ZONING COMMITTEE STAFF REPORT

FILE # 17-206-385

1. **APPLICANT:** Jon Schwartzman - MCR Property Holdings LLC **HEARING DATE:** 1/04/2018
 2. **TYPE OF APPLICATION:** Site Plan Review
 3. **LOCATION:** 1973 - 1977 Marshall Ave, at the NE corner of Moore St. (To be combined as 1975 Marshall Avenue)
 4. **PIN & LEGAL DESCRIPTION:** 332923330021; 332923330022 (Merriams Rearr of Blks 24 29 W 1o Ft of Lot 8 And All of Lot 7 Blk 27, and Merriams Rearr of Blks 24 29 E 4o Ft of Lot 8 Blk 27)
 5. **PLANNING DISTRICT:** 13 – Union Park District Council **PRESENT ZONING:** RM2
 6. **ZONING CODE REFERENCE:** §61.402(c) *Site plan review and approval.*
 7. **STAFF REPORT DATE:** 12/28/2017 **BY:** Tia Anderson
 8. **DATE RECEIVED:** 10/18/2017 **DEADLINE FOR ACTION:** 2/15/2018 (Extension Letter sent)
-

- A. **PURPOSE:** Site Plan Review for a new five-story, 16 unit apartment building with 30 structured parking spaces.
- B. **PARCEL SIZE:** 14,171 square feet, plus 998 square feet for half the alley (approx. 0.35 acres)
- C. **EXISTING LAND USE:** 1973 Marshall – one-family dwelling, 1977 Marshall – duplex
- D. **SURROUNDING LAND USE:**
North: One-, two- and multiple-family residential, ins

GRADING AND EROSION CONTROL PLAN

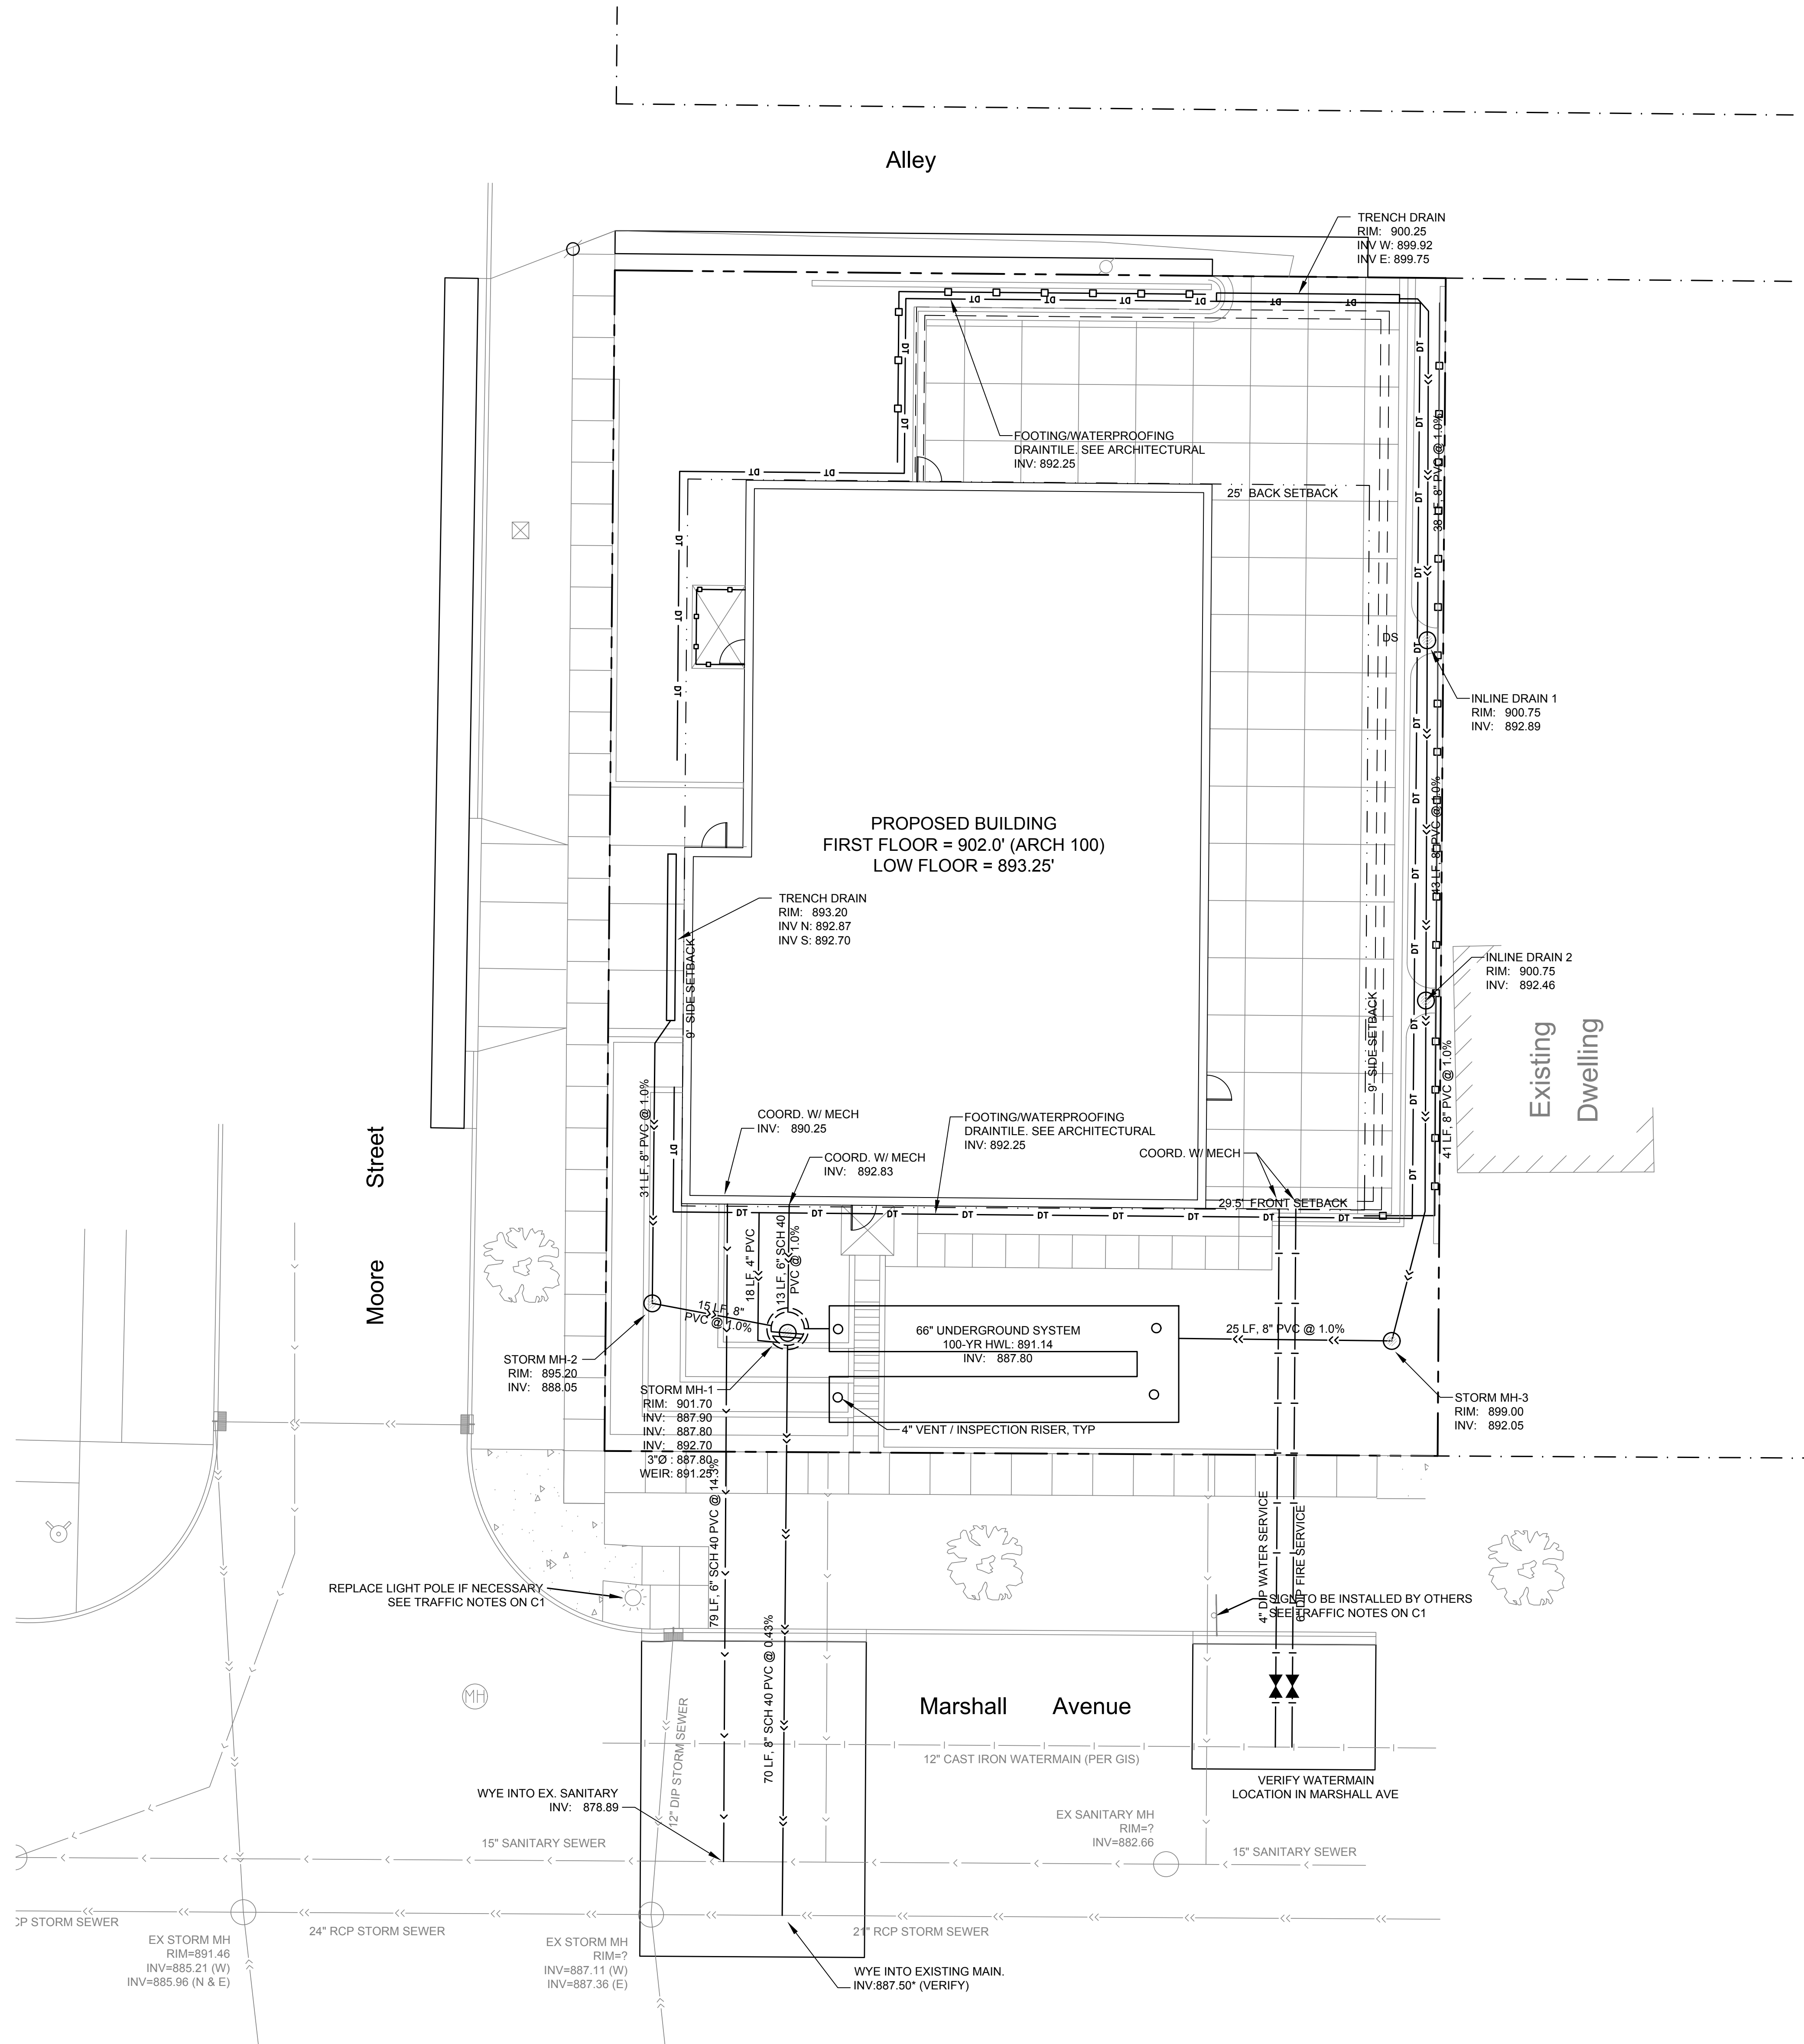
- g) On Plan Sheet C3.0 please provide a detail of the sidewalk/ramp relationship between ADA compliant ramp that starts at Marshall and parallels the Moore mainline sidewalk.

- h) On Plan Sheet C3.0 please provide catch basin erosion control devices for the catch basin at the NE quadrant of the Moore/Marshall intersection.

Response: See "Erosion Control Notes" #21 on Sheet C3.

Marshall & Moore Apartments Project Requires Major Variances to Encroach in the Rear and Interior Side Yard Setbacks for Parking Structure

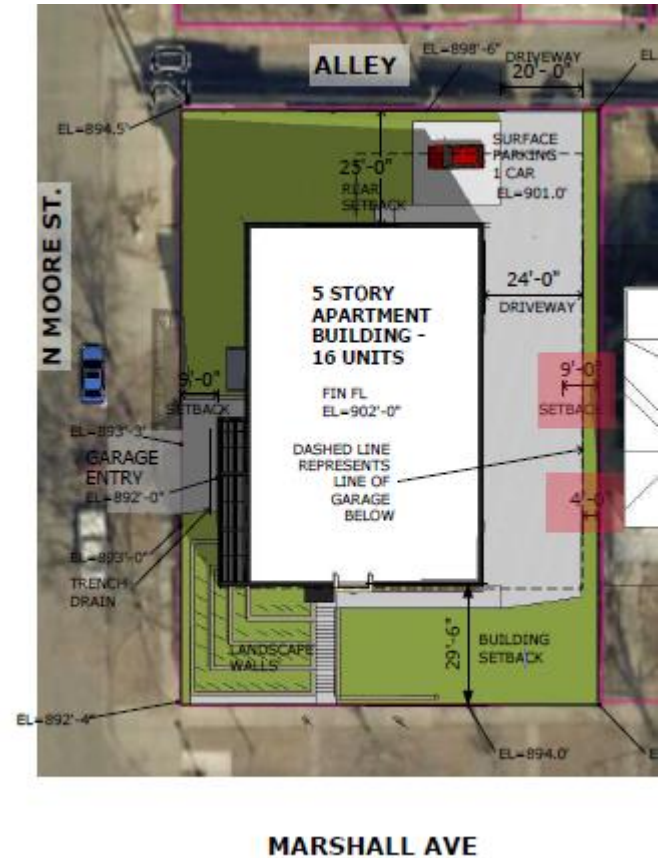
The proposed above-ground parking facility, accessed from the public alley, is located 4' from the east interior side property line and requires a major variance to encroach into the east interior side setback, required to be 9' from the property line.

The Marshall & Moore Apartments Project Requires Major Variance to Increase the Maximum Lot Coverage

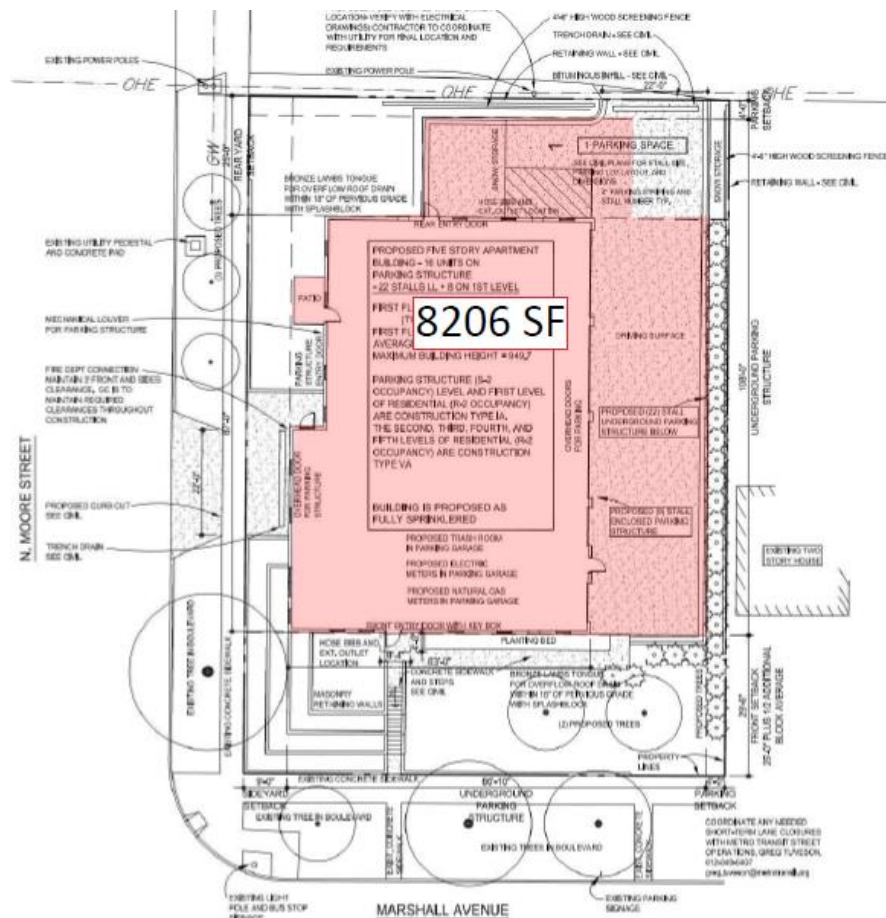
As previously demonstrated, the “underground” parking structure is 2.3’-1.94’ taller than established grade (see Exhibit C). Therefore, the entire footprint of the structure, including the “underground” parking structure, shall be included in the calculation for lot coverage.

8,206 SF / 15,169 SF = **.541 OR 54.1% of the total site area**

Marshall & Moore Apartments Project Does Not Meet Minimum Off-Street Parking Requirements

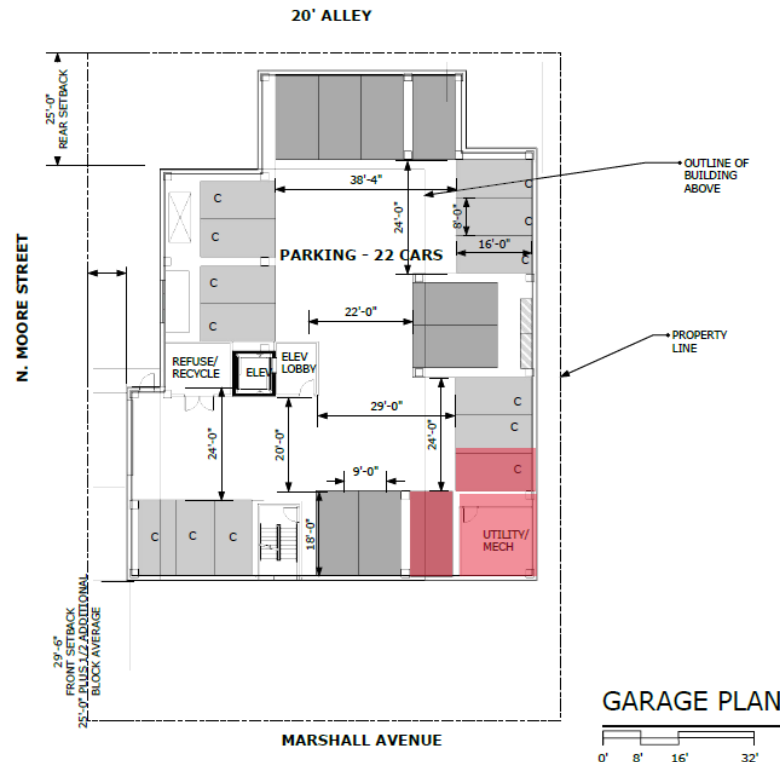
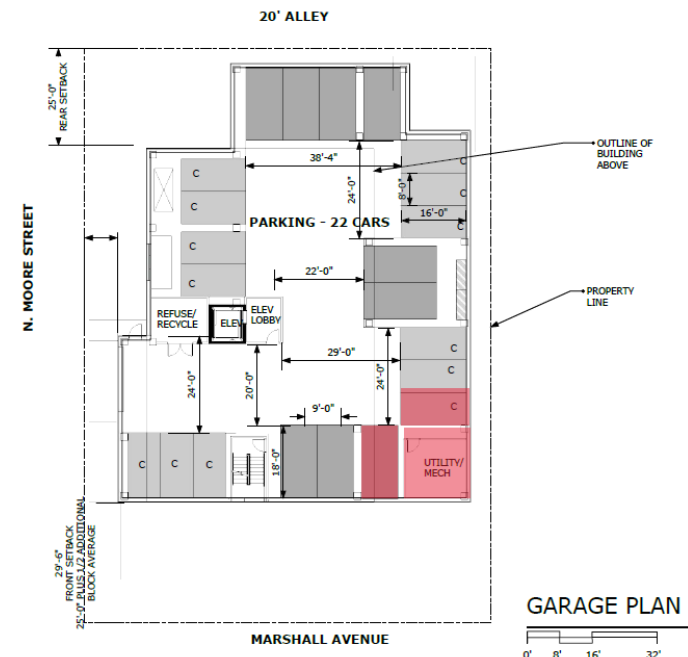
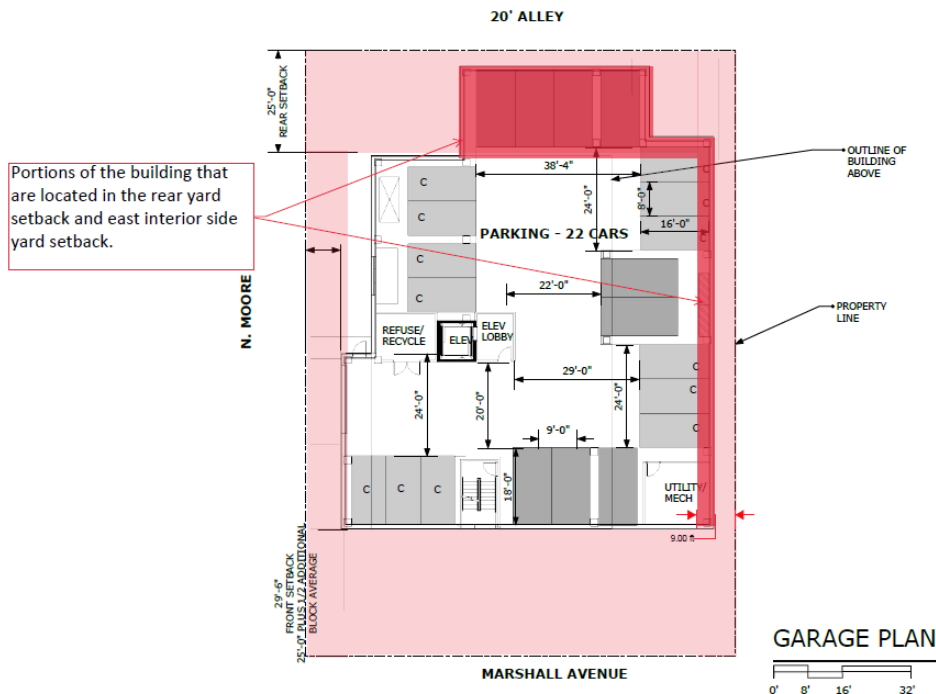
The proposed utility and mechanical room is located in the southeast corner of the “underground” parking structure. This room is flanked on both sides with parking spaces, rendering the room inaccessible. This will result in the loss of 1 parking stall to accommodate the required access to the utility and mechanical room.

As previously demonstrated, the “underground” parking is above the established grade (see Exhibit C) and 10 stalls do not comply with building setbacks and the utility and mechanical room is inaccessible (see Exhibit E), which results in the loss of 1 more parking stall. Only 20 of the proposed 31 parking stalls would not require a major variance, as shown in the Project application. A minimum of 30 parking stalls are required for 13 – 4-bedroom units and 3 – 3-bedroom units. The Project requires a variance to reduce the minimum off-street parking from 30 spaces to 20 spaces.

FIGURE LU-K. GENERALIZED 2030 LAND USES, SOUTHWEST SECTOR

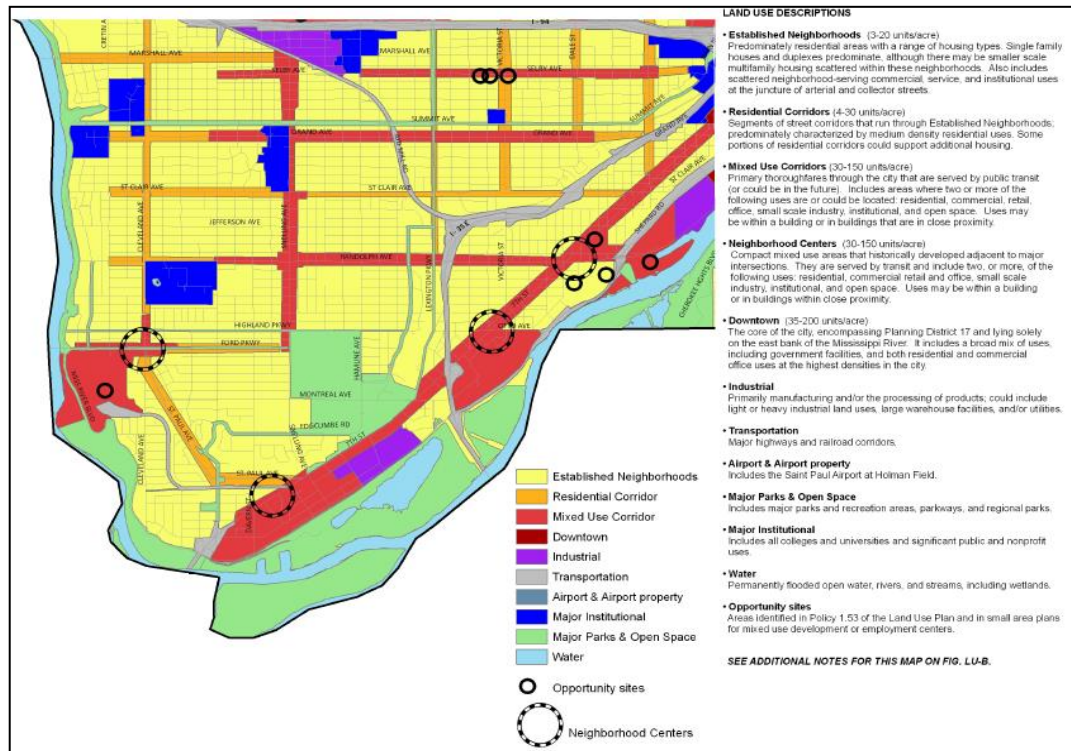
At 49 units per acre, Marshall & Moore Apartments density exceeds the St. Paul's *Generalized 2030 Future Land Use Comprehensive Plan*. Marshall Avenue is a designated Residential Corridor in the St. Paul's *Generalized 2030 Future Land Use Comprehensive Plan*. The guided density range for Residential Corridors is 4-30 dwelling units per acre and expressly stated in Strategy 1.1 and the Land Use Table.
